1 Products affected

Product hierarchy no. *				Part no.	SBU	Type / Description	Customer part no.
SBU	PG	PGU	Type				
02	006	018	0000001544	See list below	Power Entry Modules with Filters	DD22

DD22					0118.2188	
creation date	created by	release date	released by	notification no.	revision	page
2013-10-08	hollenpe	2013-12-04	hollenpe	25286	-	1 of 2

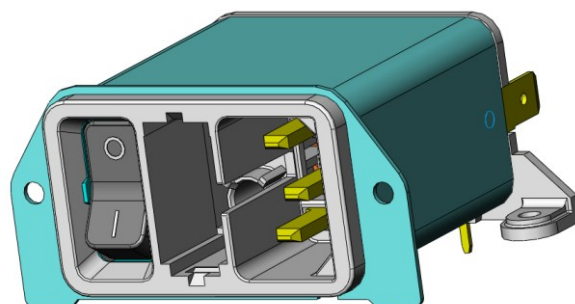
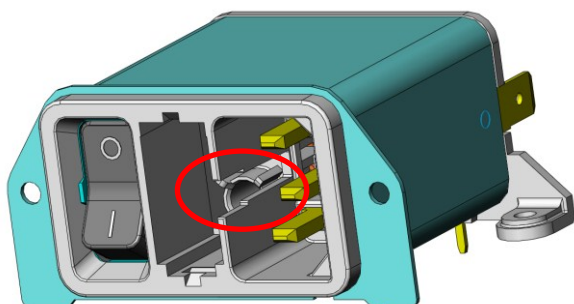
Enlarging of the fusedrawer slot.

Fusedrawer slot enlarged.

Implementaion of V-Lock cord retention function.
 Precondition: new fusedrawer required (see PCN 0118.2133)

- Form: New form is fully backwards compatible (can be used with old fusedrawer, see PCN 0118.2133).
- Fit: N/A
- Function: The new expanded slot allows applying V-Lock cord sets for cord retaining (new fuse drawer necessary).
- Production Site: N/A
- Product Label: N/A
